SERVICE BULLETIN

MD-80/90 SERIES

PASSENGER ADDRESS SERVICE INTERPHONE CALL SYSTEM (PASICS), ATTENDANT CRADLE ASSEMBLY P/N 686-2000-001, MAGNET ASSEMBLY, PRODUCT IMPROVEMENT.

686-2000-23-1

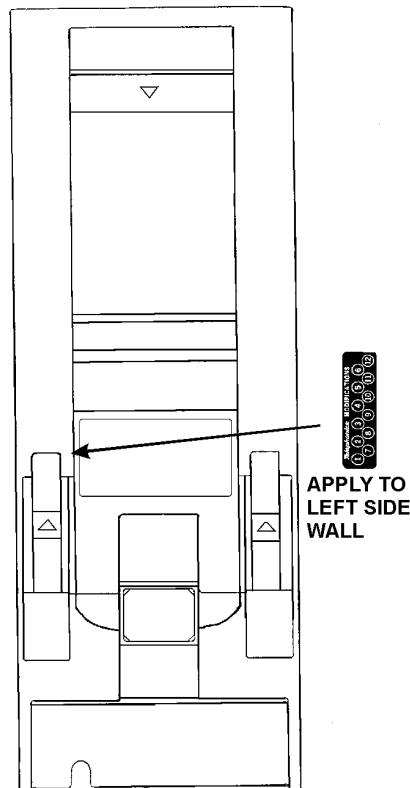
- (1) Locate magnet assembly (10) at rear of cradle housing. Remove magnet assembly using pliers, apply a quick but short rocking motion to break the adhesive grip.

- (2) Clean mounting surface on cradle plastic with a razor knife or abrasive to ensure a clean and smooth surface, making sure not to disturb the two alignment nubs in the plastic.

- (3) Apply a moderate amount of LOCTITE® 414 Liquid Bonder adhesive to the bottom plastic surface of the magnet assembly. Position magnet assembly on cradle housing, aligning holes in magnet assembly with the two nubs on cradle housing for proper positioning. If, during removal of old magnet assembly, the nubs were sheared off, align the magnet assembly using Figure 601 in Reference 1. (Note: new improved magnet assembly is marked with a REV. B)

- (4) Once aligned into proper position, hold magnet assembly in place for approximately 10 seconds to allow adhesive to set.
